Planning Sub Committee - Monday, 13th January, 2025

9. HGY/2024/2279 25-27 CLARENDON ROAD N8 0DD (PAGES 1 - 96)

Proposal: Demolition of existing buildings and delivery of a new co-living development and affordable workspace, alongside public realm improvements, soft and hard landscaping, cycle parking, servicing and delivery details and refuse and recycling provision.

Appendix 3 - Consultation Responses - internal and external consultees

Commercial

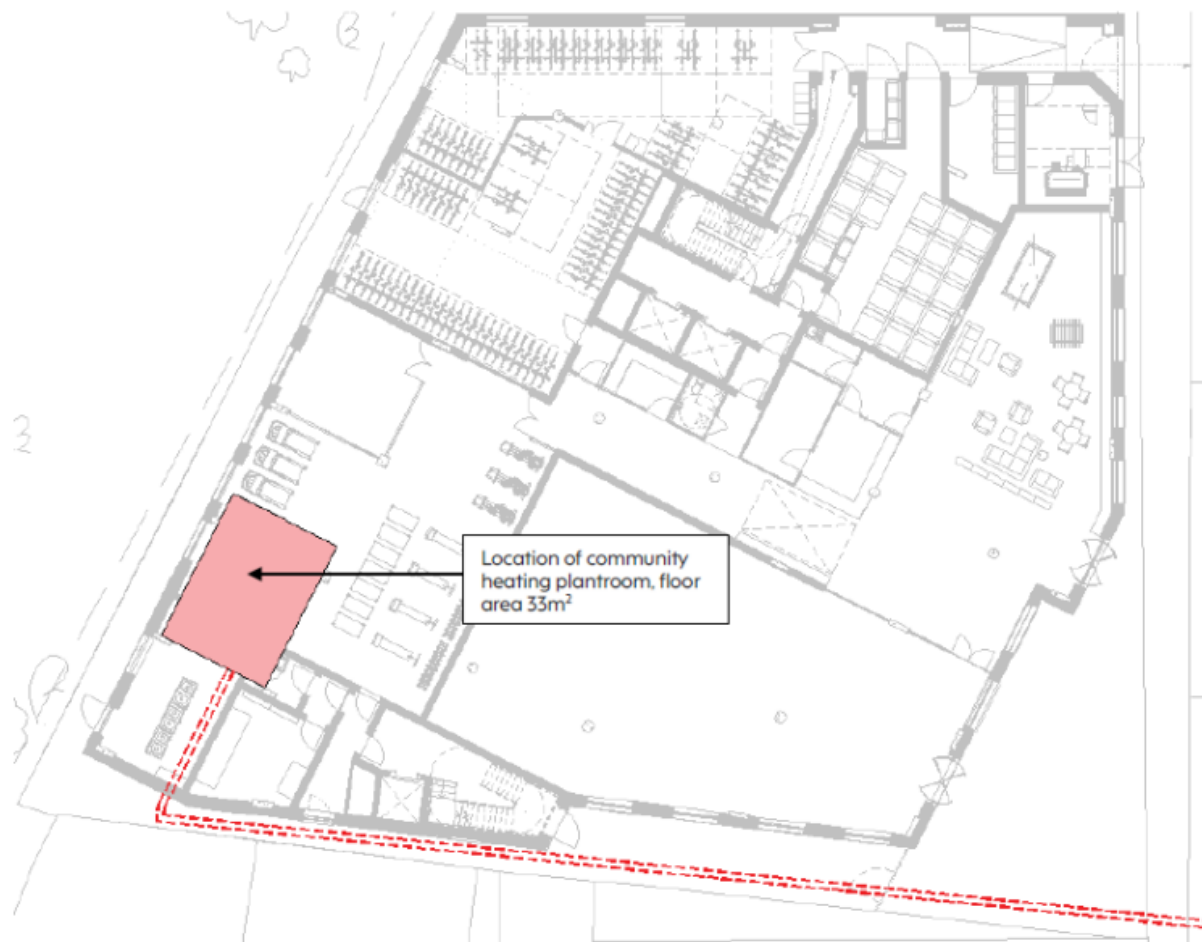
- Submit the individual end use BER for specific end users in line w CIBSE Guide F
- Justify the high cooling demand and explore measures to minimise this aiming to be within the notional cooling demand.
